ADDENDUM NO. 2

Date: January 6, 2022

Subject: **Retrofit of Swinging Bridge Over Arroyo Grande Creek, PW 2021-06**

Typical Section
Additive Alternative No. 1

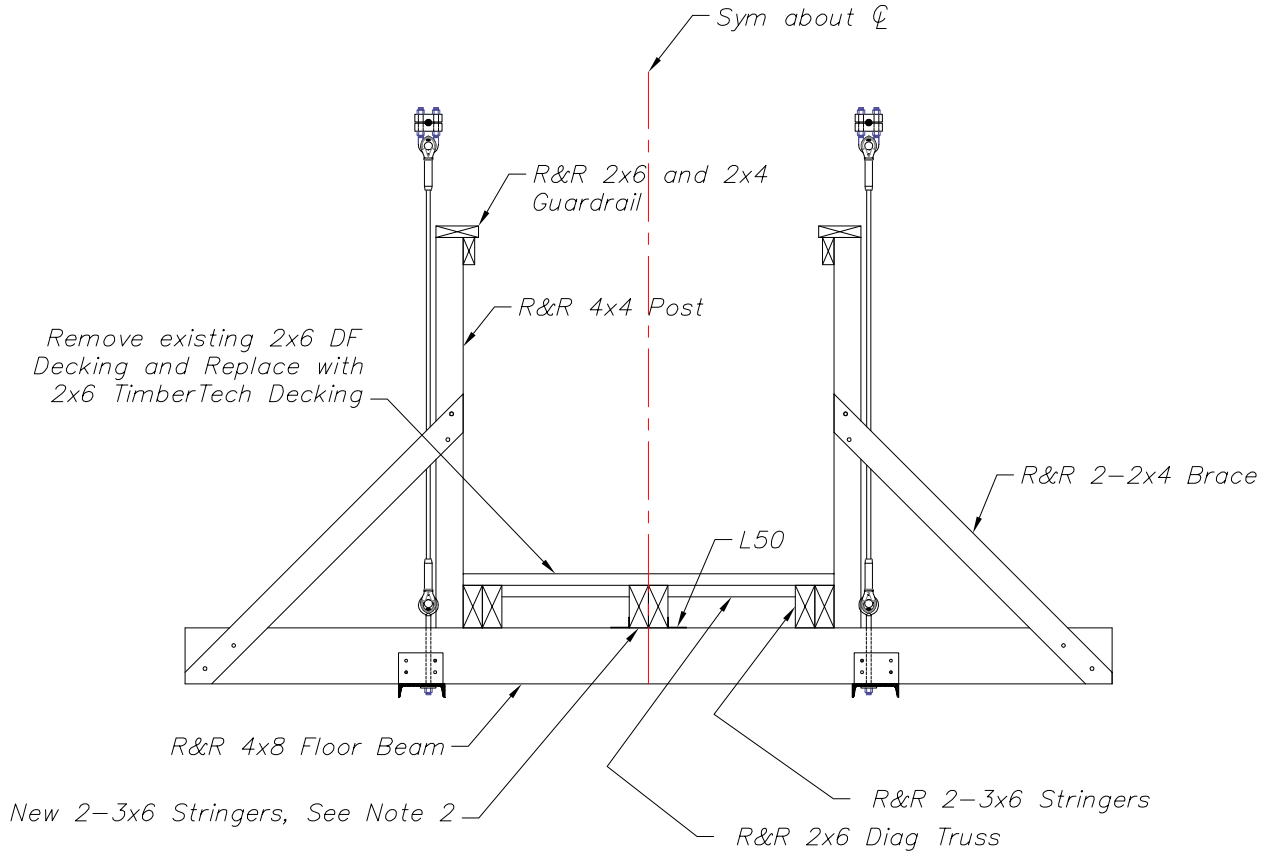
2.02	Various	<p>ADDITIVE ALTERNATE NO. 1 Add the following to the Project Plans for Additive Alternative No. 1:</p> <p>Add:</p> <ol style="list-style-type: none"> Scope of work to include the removal of existing wood members and replacing each component with new wood members. New lumber shall be pressure treated Douglas Fir No. 1. Treatment shall comply with American Wood Protection Association (AWPA) Standard U1, and Use Category UC3B. Refer to Drawing X1 attached to this Addendum. Existing South Ramp, posts and rails shall be replaced in kind. Refer to As-Built Plans prepared by Fred H. Schott and Associates for wood details, connection details and material specifications. Remove and reinstall steel plates, bolts, angles, channels, stringer splice, and chain link fabric as required for the installation of the new wood members. Provide new wood screws for screwed wood connections. Remove and replace cable hangers at each floor beam concurrently with the installation of each floor beam. Wood removed from structure is treated wood waste. Comply with 2018 Caltrans Standard Specifications Section 14-11.14A. Contractor must submit a demolition and erection plan for approval which includes provision for maintaining the existing cable profile when the floor beam is removed.

1. *R&R = Remove Existing Member and Replace with New Wood Member*
2. *New lumber shall be pressure treated DF No. 1. Treatment shall comply with AWP A U1, Use Category UC3B.*

1 **Typical Section**
X2 Additive Alternative No. 2

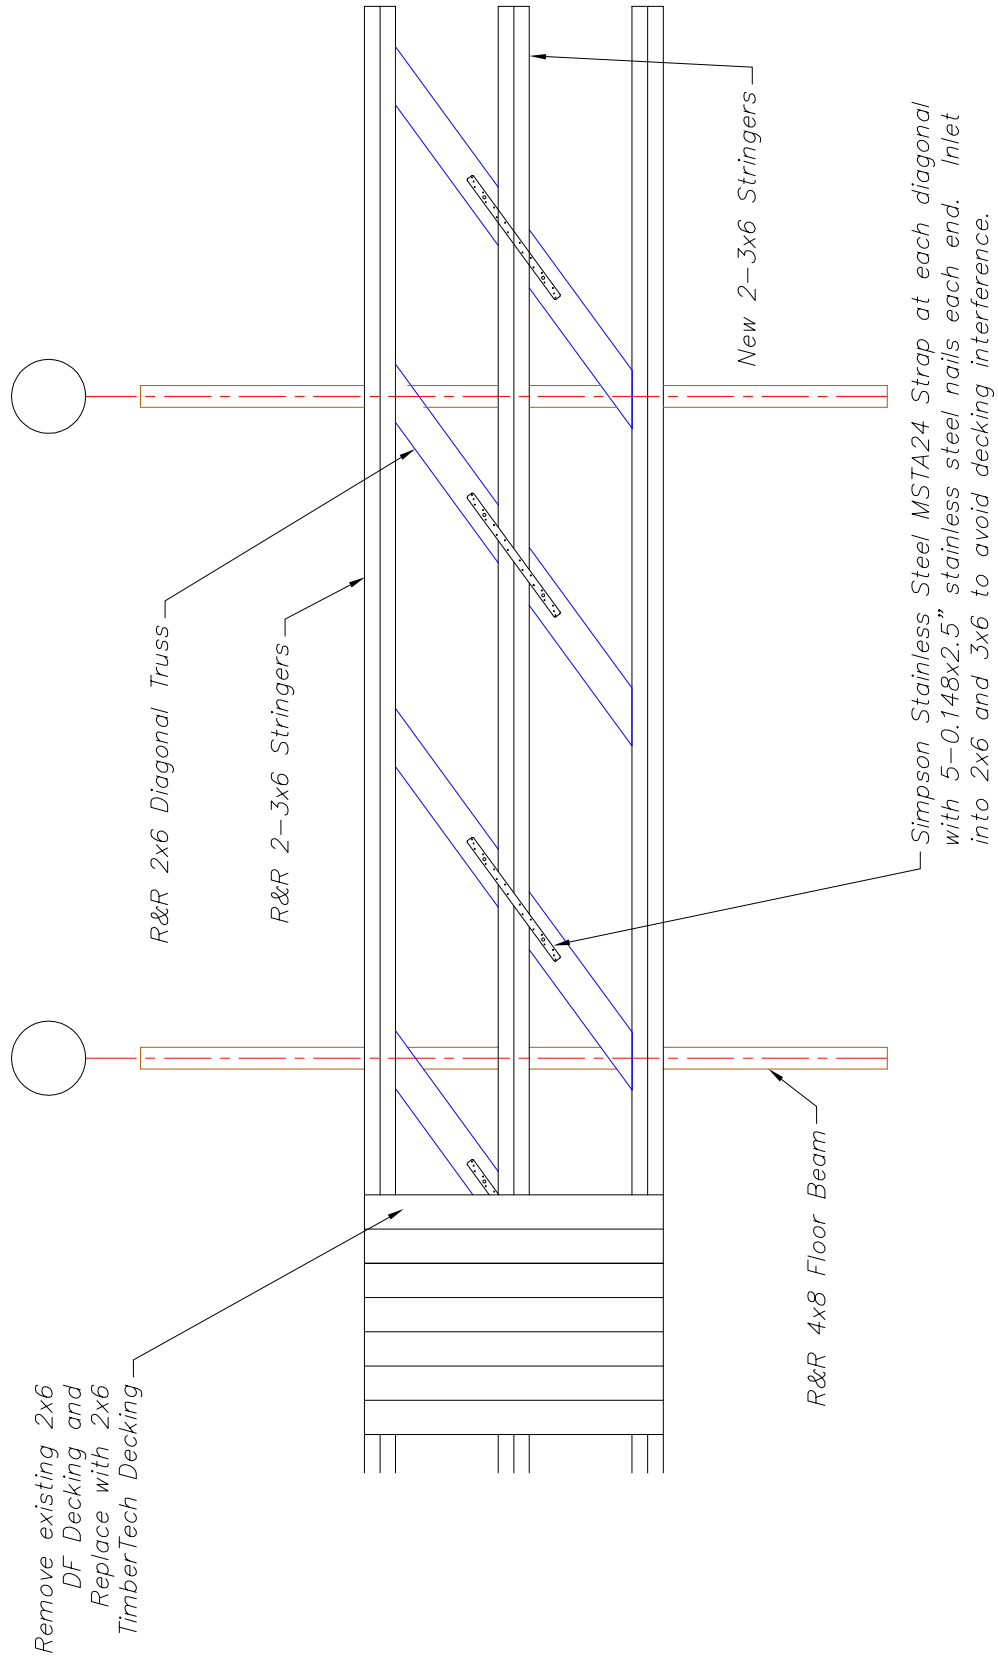
Add. Item	Sheet	Description of Change
2.03	Various	<p>ADDITIVE ALTERNATE NO. 2 Add the following to the Project Plans for Additive Alternative No. 2:</p> <p>Add:</p> <ol style="list-style-type: none"> 1. Scope of work to include the removal of existing wood members and replacing each component with new wood members. New lumber shall be pressure treated Douglas Fir No. 1. Treatment shall comply with American Wood Protection Association (AWPA) Standard U1, and Use Category UC3B. The decking shall be TimberTech AZEK Harvest Collection Max Deck Boards (1.5" x 5.5") or approved equal. Refer to Drawings X2 and X3 attached to this Addendum. 2. Existing South Ramp, posts and rails shall be replaced in kind. 3. Refer to As-Built Plans prepared by Fred H. Schott and Associates for wood details, connection details and material specifications. 4. Remove and reinstall steel plates, bolts, angles, channels, stringer splice, and chain link fabric as required for the installation of the new wood members. 5. Provide new wood screws for screwed wood connections. 6. Remove and replace cable hangers at each floor beam concurrently with the installation of each floor beam. 7. Wood removed from structure is treated wood waste. Comply with 2018 Caltrans Standard Specifications Section 14-11.14A. 8. Contractor must submit a demolition and erection plan for approval which includes provision for maintaining the existing cable profile when the floor beam is removed.

1. R&R = Remove Existing Member and Replace with New Wood Member
2. New Center Stringer Installation:
 - a. Refer to As-Built Plans Details C/S2 and G/S2.
 - b. Connect stringer to abutments per As-Built Detail H/S2 as modified by Project Plan Detail 2/S7.
 - c. Provide Simpson L30 or approved equal to connect each 3x6 to 4x8 Floor Beam using 4-0.148x1.50" stainless steel nails.
3. TimberTech decking shall be Azek Harvest Collection Max Deck Boards (1.5"x5.5") or approved equal. Provide #10x3" stainless steel deck screws to each 3x6. In addition provide fasteners as noted in As-Built Details C & D/S2.
4. New lumber shall be pressure treated DF No. 1. Treatment shall comply with AWP A U1, Use Category UC3B.
